# Intel<sup>®</sup> StrongARM<sup>®</sup> SA-1100 Multimedia Development and SA-1101 Development Boards

Specification Update

*April 1999*

Order Number: 278245-001

**Figure 1. Etch Cut under C35**

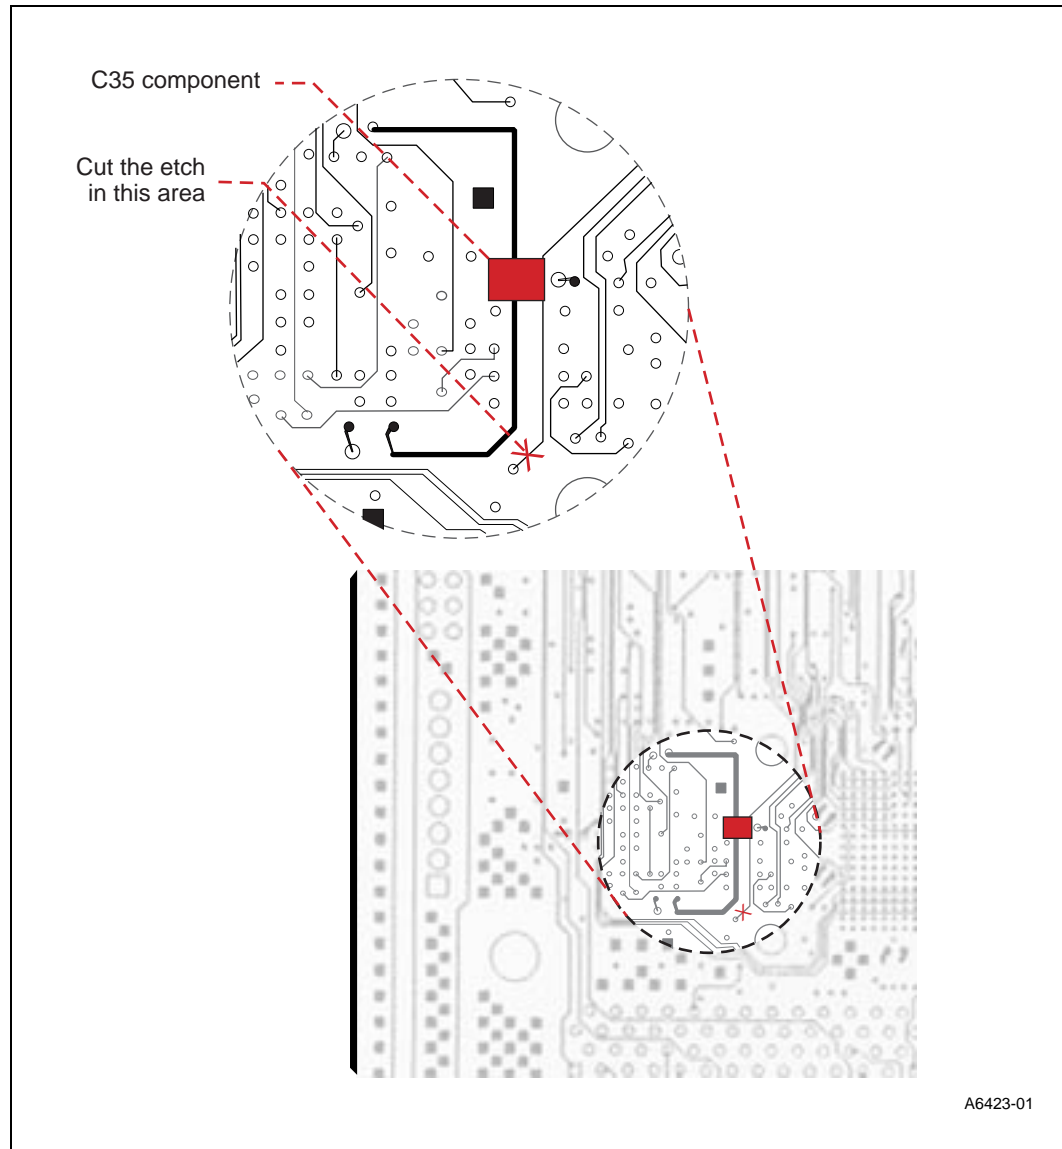
**Problem:** Video from VGA may be unstable due to loading on signal GPIO\_CLK\_27 is incorrect.

**Implication:** May cause an unstable SA1100 PLL signal, which may result in video jitter or intermittent USB errors.

**Workaround:** Cut the etch that runs under the side two component C35 (see Figure 1).

**Figure 2. Keyboard Connectors**

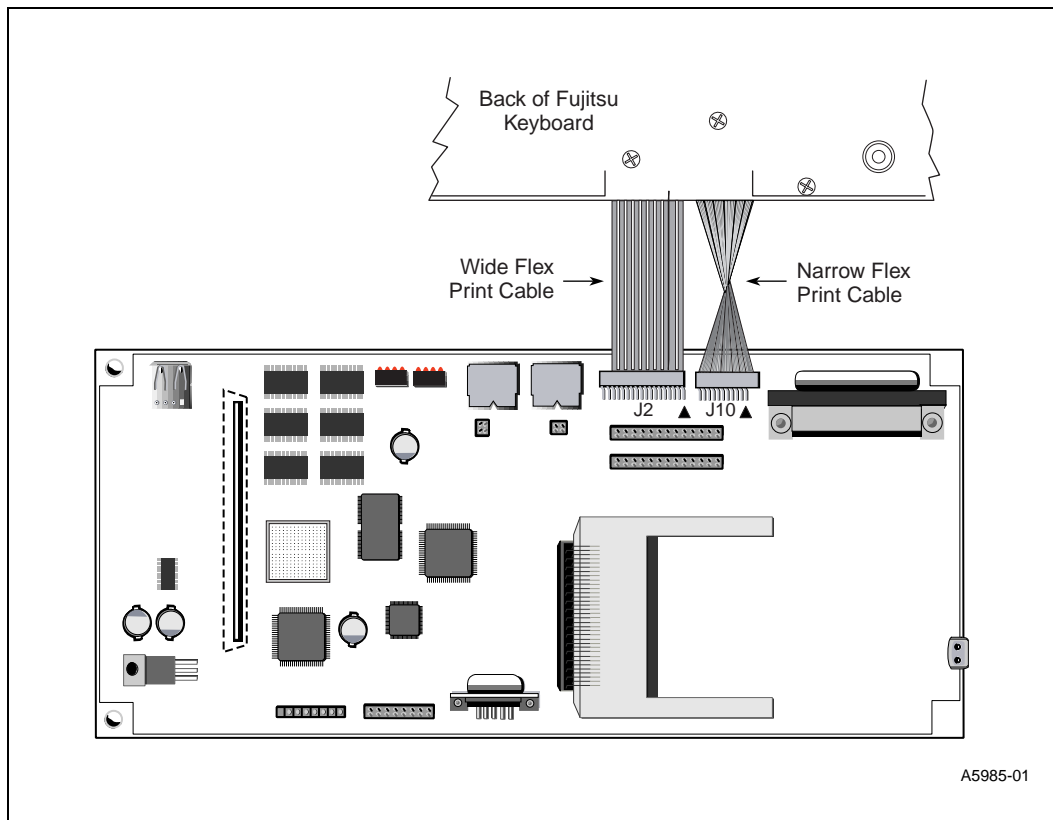
**Problem:** The narrow flex print cable for the Fujitsu keyboard, model number N860-1406-T001, will not make an electrical contact with J10 on the SA-1101 development board.

**Implication:** The Fujitsu keyboard will not function.

**Workaround:** Use the following procedure for connecting the Fujitsu keyboard to the SA-1101 development board (see Figure 2):

1. Locate J2 and J10 on side one of the SA-1101 development board.

2. Turn over the Fujitsu keyboard onto its keys and align pin 1 of the wide flex print cable with pin 1 of J2.
3. Insert the wide flex print cable into J2.
4. Twist the narrow flex print cable so that the black surface of the cable is facing upward, similar to the wide flex print cable.
5. Align pin 10 of the twisted narrow flex print cable with pin 10 of J2.
6. Insert the twisted narrow flex print cable into connector J10.

Figure 3-1. SA-1100 Multimedia Development Board

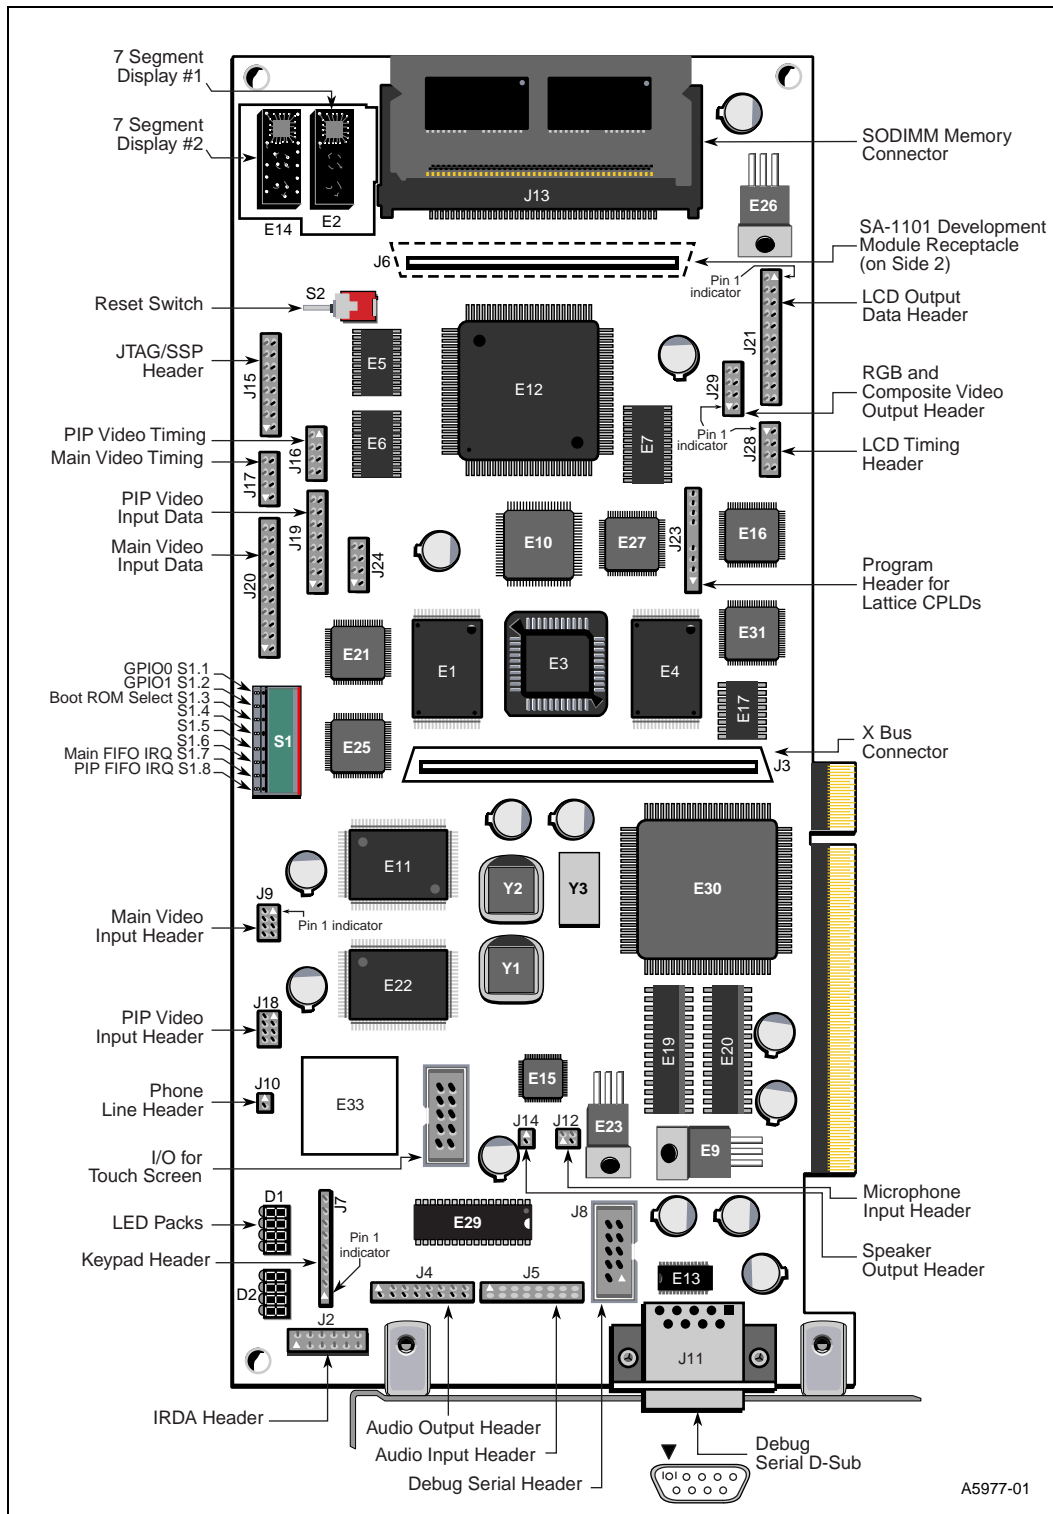
- Changed the name of J11, “Debug Serial Header #2” to “Debug Serial D-Sub.”
- Changed the name of J8, “Debug Serial Header #1” to “Debug Serial Header.”
- Added “Boot ROM Select,” “Main FIFO IRQ,” and “PIP FIFO IRQ” to S1.

Figure A-2. S1, S2, LEDs, Keypad, Debug, X Bus, Daughter Card and SODIMM Connector

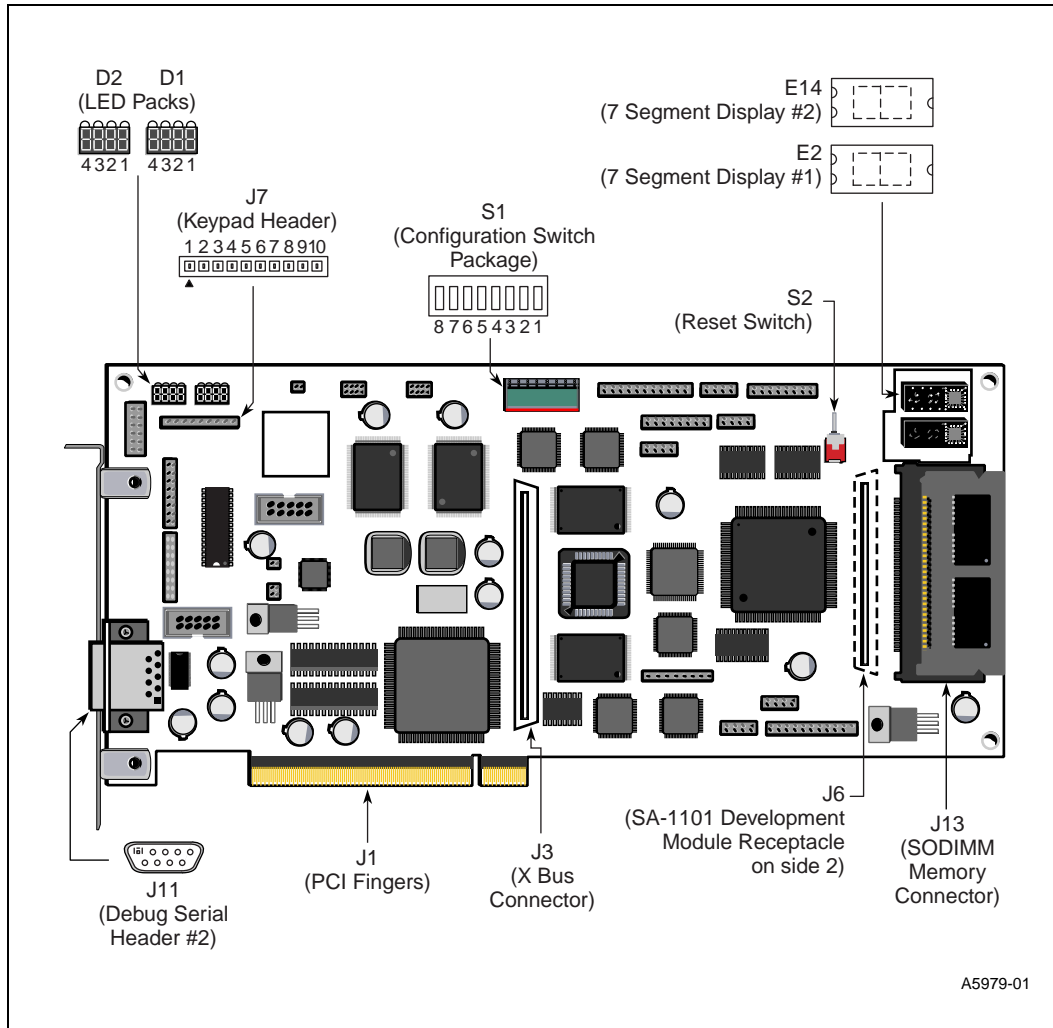
Added J6, SA-1101 Development Board Receptacle and J3, X Bus Connector.

**Figure A-6. IrDA, JTAG, LCD, and Debug Ports and Headers**

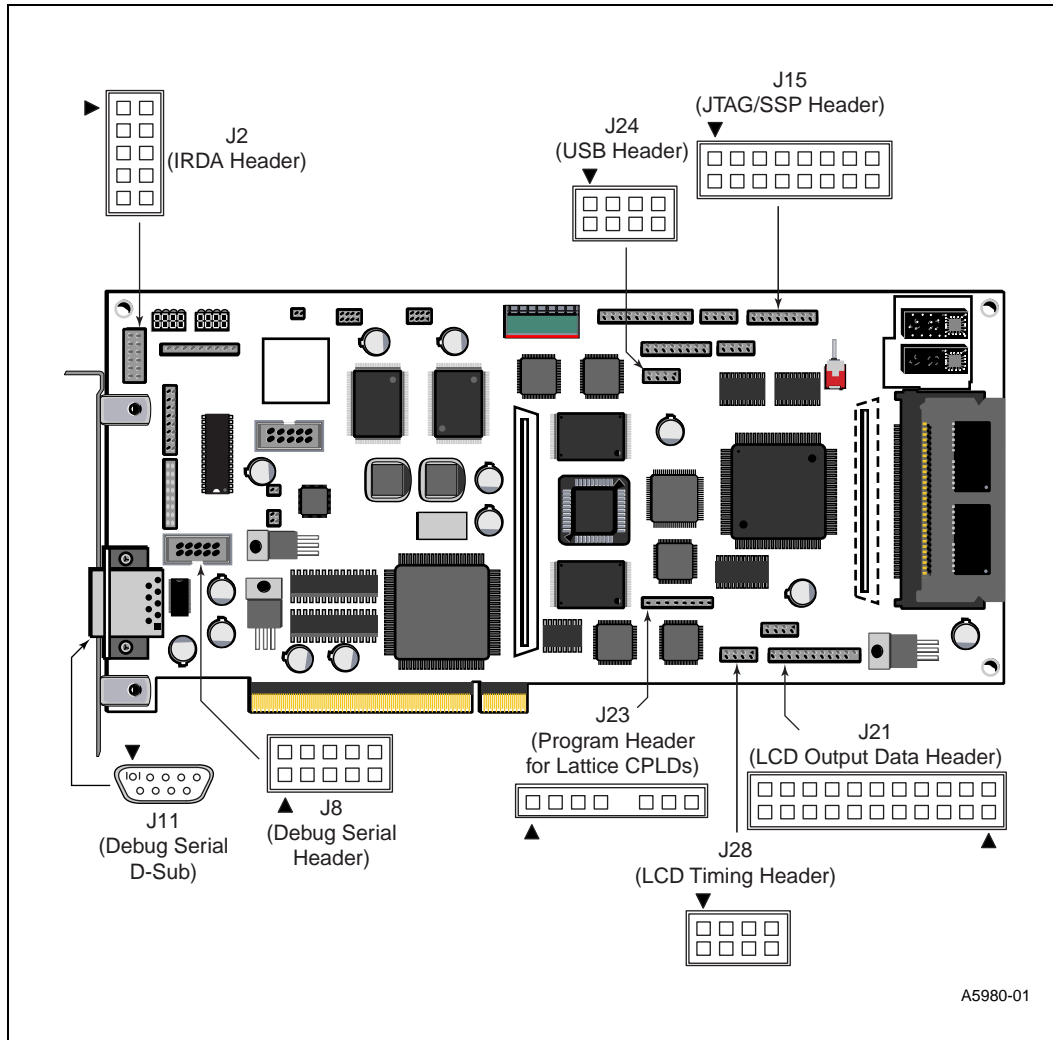
- Changed the name of J8, “Debug Serial Header #1” to “Debug Serial Header.”
- Changed the name of J11, “Debug Serial Header #2” to "Debug Serial D-Sub."

Figure 3-2. SA-1101 Development Board

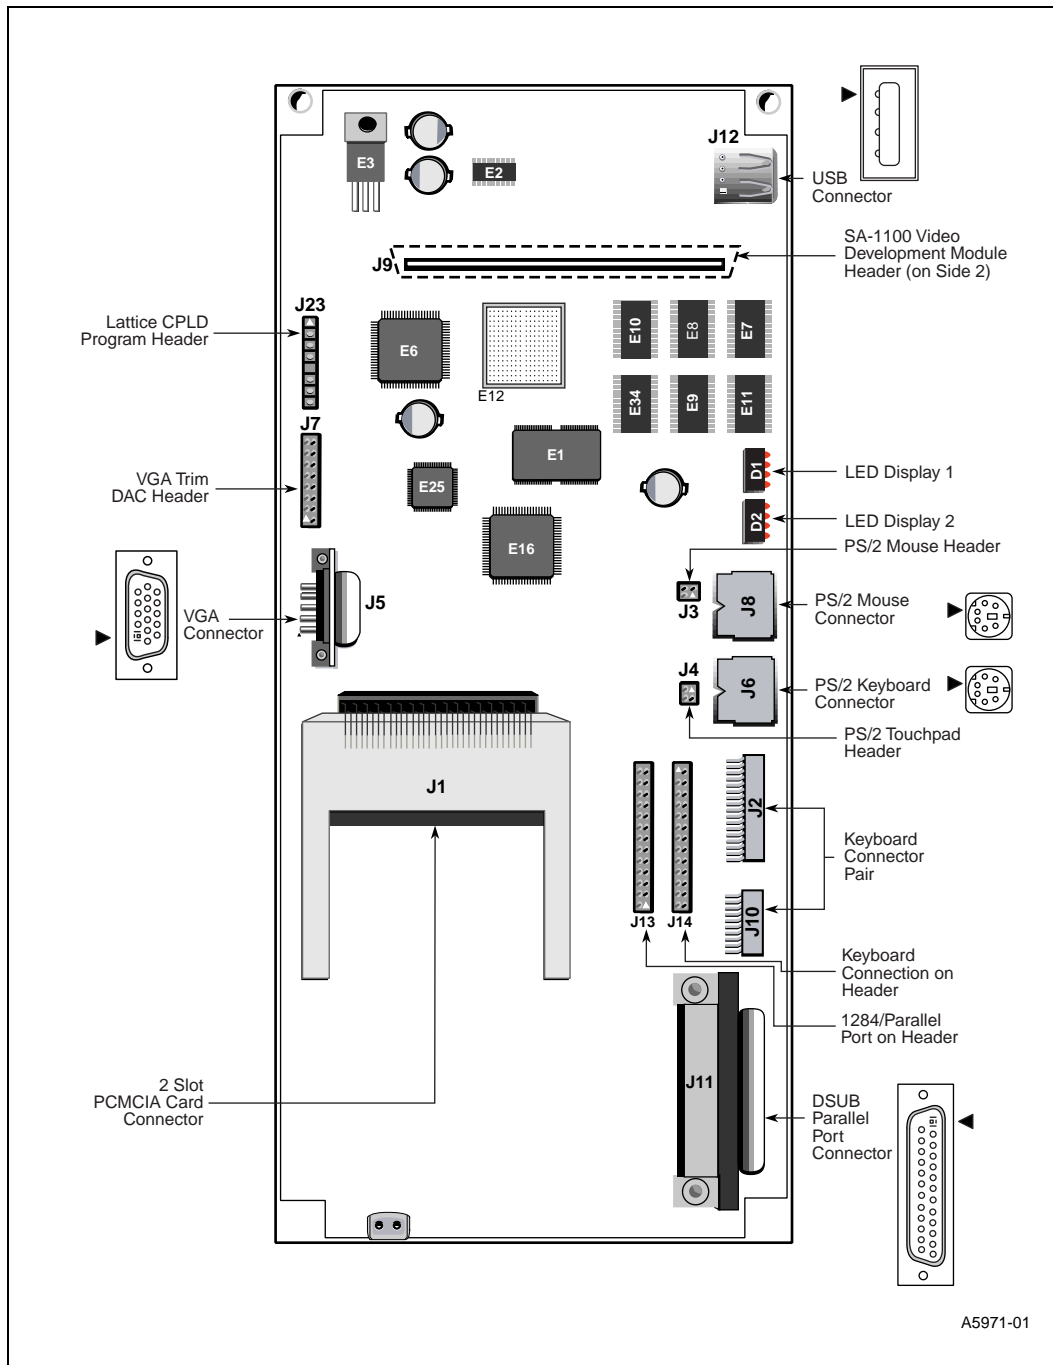
1. **Optional SA-1101 Development Board: Figure 3-2, Figure B-1**
  - Changed the name of J5, “RGB Cable Connector” to “VGA Cable Connector.”
  - Changed the name of J7, “RGB Trim DAC Header” to VGA Trim DAC Header.”

**Figure 3-5. Keyboard Connectors**

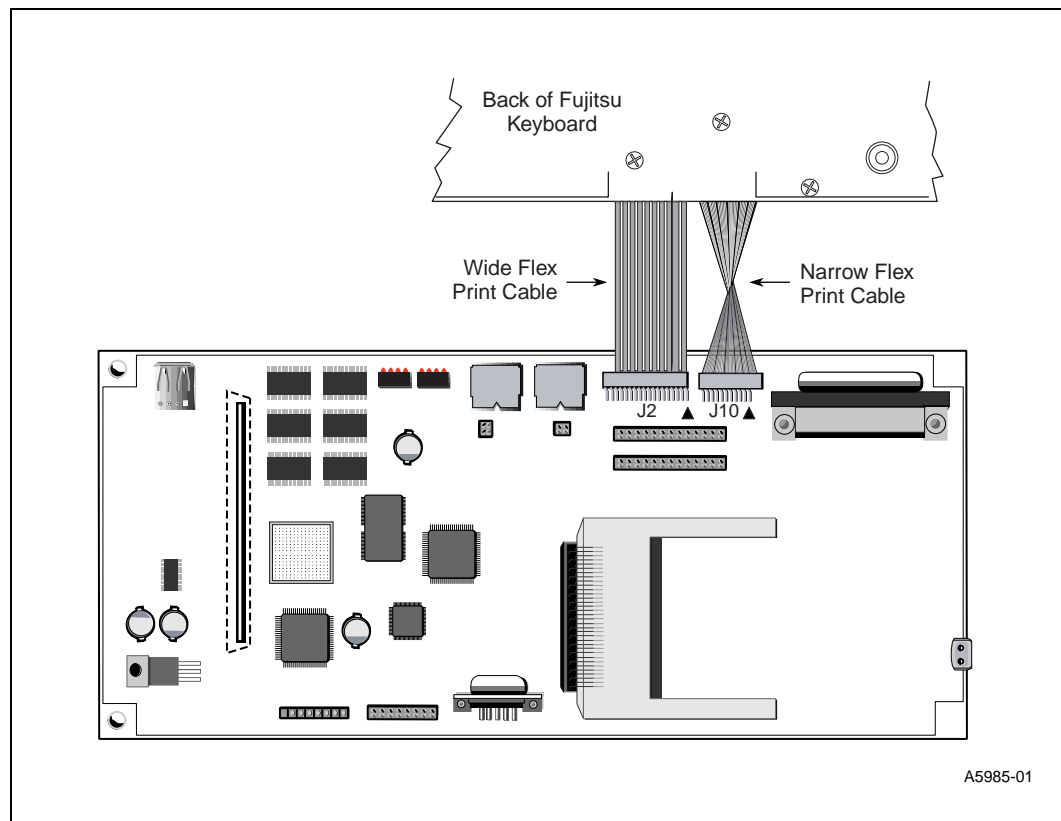
Changed the procedure for connecting the narrow flex print cable, changed the number of pins from 9 pins to 15 pins, changed the name of “RGB connector” to “VGA connector,” and “RGB Cable Connector” to “VGA Cable Connector,” and ribbon cable to flex print cable.

**Note:** The flex print cables for the keyboard are center justified with connectors J2 and J10, resulting in unused pins on the left side of J2 and on the right side of J10. Please see Figure 3-5 for proper insertion of the keyboards two flex print cables.

1. Locate J2 and J10 on side one of the SA-1101 development board.
2. Turn over the Fujitsu keyboard onto its keys and align pin 1 of the wide flex print cable with pin 1 of J2.
3. Insert the wide flex print cable into J2.
4. Twist the narrow flex print cable so that the black surface of the cable is facing upward, similar to the wide flex print cable.
5. Align pin 10 of the twisted narrow flex print cable with pin 10 of J2.
6. Insert the twisted narrow flex print cable into connector J10.
7. Attach the 15-pin VGA connector (not provided) into J5, VGA Cable Connector, aligning the socket connections. Attach the other end of the connector to a color monitor or LCD display.

Figure B-3. Keyboard Connectors

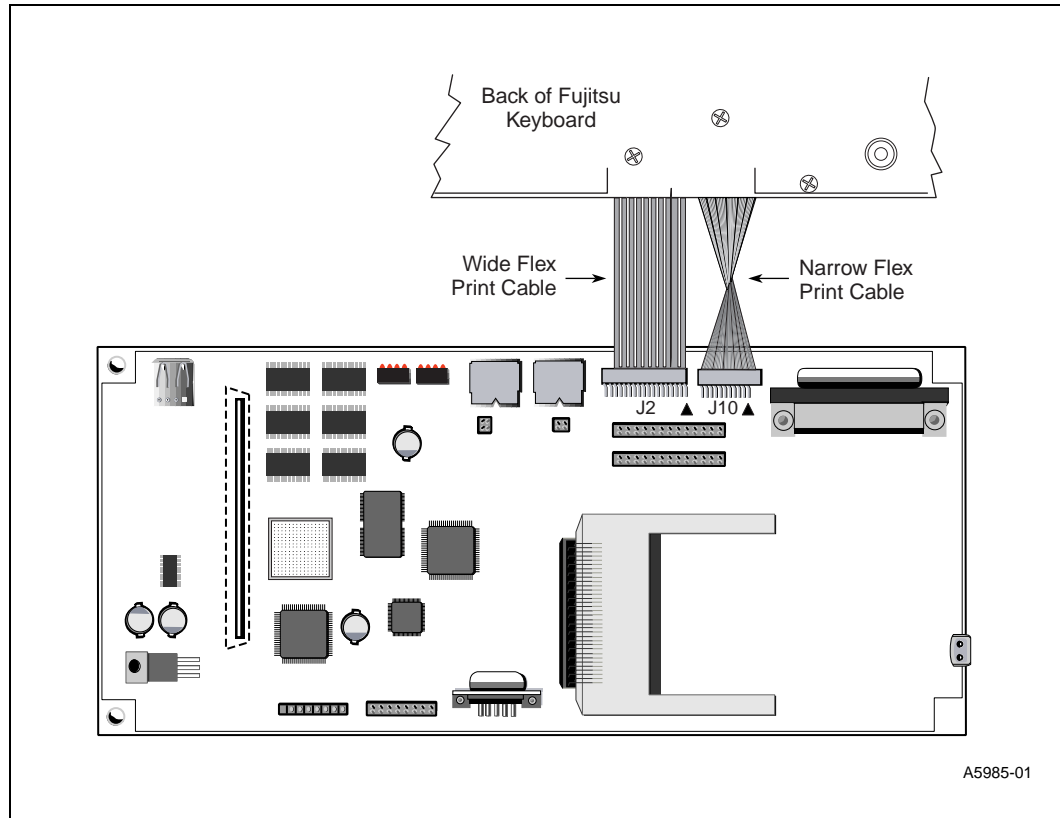
The figure now appears as follows, indicating a twist in the narrow flex print cable:
